Subject: FINAL DANGEROUS AND/OR MIXED WASTE RESEARCH, DEVELOPMENT, AND DEMONSTRATION PERMIT FOR THE DEMONSTRATION BULK VITRIFICATION FACILITY: DESIGN - AGREED TO REVISIONS FOR SECONDARY WASTE AND WASTE DRYER SYSTEM DESIGNS

FINAL DANGEROUS AND/OR MIXED WASTE RESEARCH, DEVELOPMENT, AND DEMONSTRATION PERMIT FOR THE DEMONSTRATION BULK VITRIFICATION FACILITY: DESIGN – AGREED TO REVISIONS FOR SECONDARY WASTE AND WASTE DRYER SYSTEM DESIGNS

REVIEW COMMENT RECORD (RCR)

Figure 2 Dryer and Condensate Interface Diagram

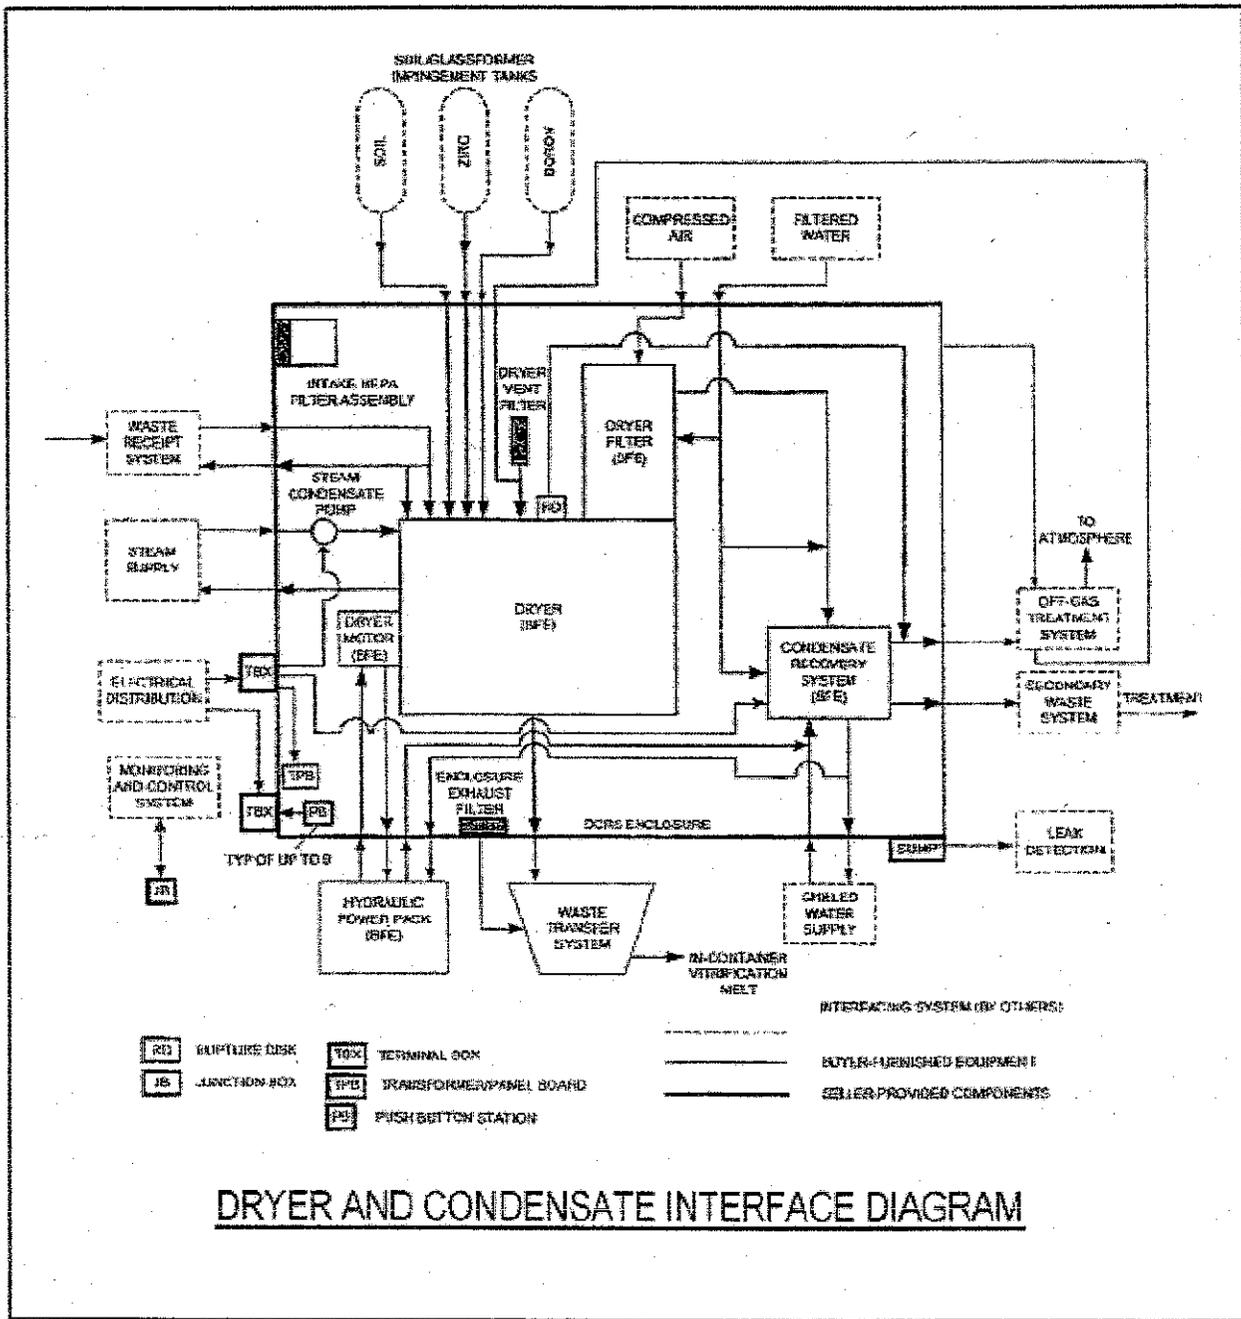
Item	Location in Document	Comment	Hold Point	Disposition (Provide justification if NOT accepted.)	Status
				recommend optimum dryer size/usage for a multiple melt train facility.	
2	IQRPE Report No. DR-009, Rev. 0; p. 7; Fig. 2 Note: This Comment was transferred from Dryer RCR Part 2, Comment #2 (Aug 17, 2005)	<ul style="list-style-type: none"> On P&ID, F-145579-33-0100, the rupture disk is "set at 5 psig". On p. G2-433 the design pressure of the rupture disk is given as 15 psig at 250°F. Please clarify what the design pressure means in this context. Can this one rupture disk be set at different pressures; if so, what is the lowest design pressure specification? The normal operating temp in the dryer is 140 °F so it appears that for adequate protection the specification of the rupture disk should state a temperature less than 140 °F instead of 250°F. Also review IQRPE evaluation in Section 2.2.3.1 in light of this comment. <u>Please explain your claim (by default) that the pressurization of the dryer by pluggage of the C-bed or other off gas equipment is an incredible scenario. Also, leaked steam at 250 °F when combined with the dryer contents at 140 °F will result in a temperature less than 250 °F. It appears that a rupture disk rated at 250 °F (instead of a lower temperature) would provide no protection in this case. This comment is also directed towards the IQRPE and his response is requested with reference to Section 2.2.3.1 of his report)</u> The rupture disk is shown leading to the Off gas Treatment System (OGTS) immediately downstream of the Waste Dryer Vacuum Off gas Condensate Tank, 33-D74-033. However, rupture disks are an important last resort safety item that should preferably be vented directly to the atmosphere. One scenario for pressurization of the dryer would be the plugging up of the off gas system causing the vacuum pump to be ineffective. In that situation it is not clear how the rupture disk would serve its purpose. <p><u>If the off gas train were to plug up, it is conceivable that the dryer could get pressurized even with the vacuum pump running (with the discharge of the vacuum pump blocked it would not provide any function. Even if the rupture disk were to blow, the contents of the dryer would have no outlet. This could</u></p>	X	The design pressure for the rupture disk is for the rupture disk housing. Per ASME the temperature of the rupture disk is defined as the temperature at which the disk is expected to burst. The only credible way of pressurizing the inside of the dryer would be by a leak of steam from the jacket directly into the dryer shell. The steam is 15 psig and 250 F. The steam would initially be superheated as it entered the dryer. Little cooling would be expected for a steam leak of such a size as to cause a rapid pressure increase. The burst temperature would be the temperature of the steam in the jacket. If steam leaks into dryer, head space of dryer will become 250 F rapidly, prior to dryer contents coming to equilibrium. If not, dryer will not need to vent. IQRPE report indicates rupture disk and off-gas pipe the rupture disk vents to is adequately sized. Rupture disk is vented into 6" diameter pipe routed to the off-gas system which will allow the rupture disk to perform its function while still providing containment	Closed 8/31/05

Item	Location in Document	Comment	Hold Point	Disposition (Provide justification if NOT accepted.)	Status
		<p>result in a catastrophic breach in the dryer/off gas system. <u>Has this scenario been evaluated? If it seems illogical to vent the rupture disk outlet inside the dryer enclosure, conceivably discharge from the rupture disk could be routed to a dedicated tank for subsequent pressure relief through a HEPA filter to the atmosphere.</u></p> <p>2.a. Please refer to G2-590 (Rupture Disk Spec sheet) Line 18; Max. vacuum is given as <u>250 °F</u>. This entry needs to be corrected.</p> <p>2.b. Moreover, the dryer is rated for 5 psig. Per routine Engineering practice it should be safeguarded against pressure surges at a pressure <u>below 5 psig</u>. It is unclear how the rupture disk as specified (5psig at 250°F) will provide a safety margin. Please have a safety engineer do a risk assessment of a pressurization event inside the dryer. In particular, evaluate the adequacy of the specification of the rupture disk and also its physical connection shown in P&ID F-145579-33-A-0100. Also please have the IQRPE reevaluate, and appropriately revise, the 1st para of Section 2.2.3.1 of his report, DR-009.</p>		<p>for the hazardous material. If the rupture disk was vented to the dryer enclosure on an overpressure event, dried waste product would be released into the enclosure, resulting in significant personnel exposure to hazardous chemicals and radioactive material.</p> <p>If off-gas system is plugged, system will be shut-down. Several pressure indicators throughout the dryer off-gas treatment system and the main OGTS will provide operator indication that system is plugged and requires shut down. Need about 300 ft of off-gas piping to vent entire volume of dryer. About 500 ft available in DBVS OGTS.</p> <p>Vendor data sheet for rupture disk will be provided upon receipt of Dryer skid design.</p> <p>2.a. Agreed. Line 18 will be changed to “Maximum Temp” at next revision of D-SP-006.</p> <p>2.b. The dryer design package was reviewed and evaluated by CH2M HILL industrial safety, nuclear safety and the design</p>

Item	Location in Document	Comment	Hold Point	Disposition (Provide justification if NOT accepted.)	Status
				<u>authority along with Closure Projects Engineering. Further, the IQRPE has reviewed the adequacy of this portion of the design in his report. No change.</u>	
3	IQRPE Report No. DR-009, Rev. 0; p. 9; 5 th line Note: This Comment was Transferred from Dryer RCR Part 2, Comment # 3 (Aug 17, 2005)	The IQRPE report states there is one condenser in the off-gas line from the dryer. P&ID (F-145579-33- A-0101) shows there are two condensers in the off-gas line from the dryer. Please explain discrepancy. <u>Please consider revising the nomenclature of 33-D10-032 ("Waste Dryer Vacuum off-gas Condenser") in the Dryer Vacuum P&ID, F-145579-33-A-0101.</u> 3.a. You state that 33-D10-032 acts to <u>cool the water</u>. Please explain why the unit is called a "condenser".		Strictly speaking, 33-D10-005 acts to condense the dryer <i>off-gas</i> . 33-D10-032 acts to cool the water for the liquid seal on the vacuum pump. The 3 rd sentence on p. 9 is accurate as written. Accurate as written. No change necessary 3.a. The description as stated is accurate; however, to accommodate the review comment, the equipment title will be changed to "Liquid Seal Heat Exchanger" and will also change the symbol used on the P&ID to match.	Closed 8/31/05

Figure 4 Rapid Interactive Structural Analysis (RISA) Sample Output

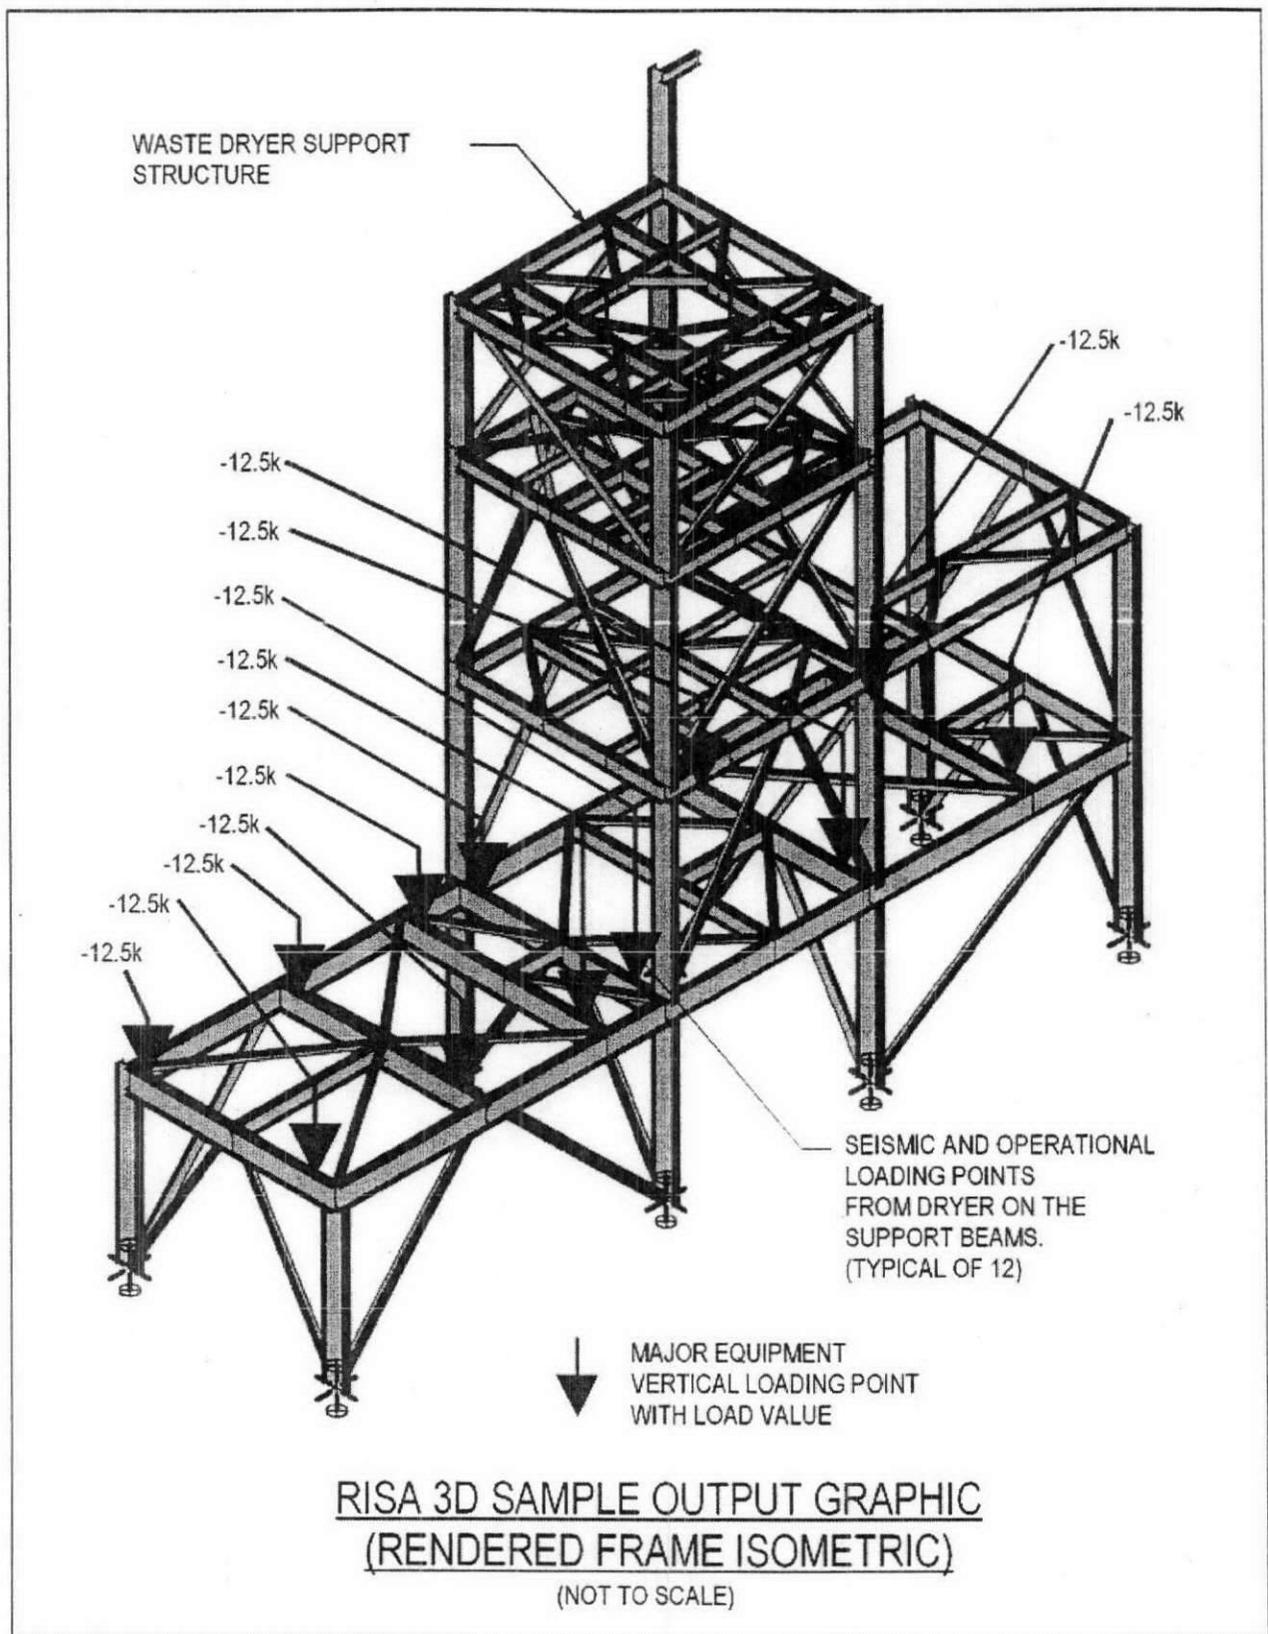
4	IQRPE Report No. DR-009, Rev. 0; p. 17; Fig. 4	How accurate is the dryer load cell readings given the vibration in the dryer body due to the mixer. This dryer weight is crucial to determine the % moisture and thereby the end point of drying. <u>Is the dryer on load cells? How much experience does the dryer manufacturer</u>	X	Materials loaded into the dryer (soil, waste, additives) are primarily controlled and metered in via the material input systems. Load-cells on the soil and glass former impingement tanks provide	Closed 8/31/05
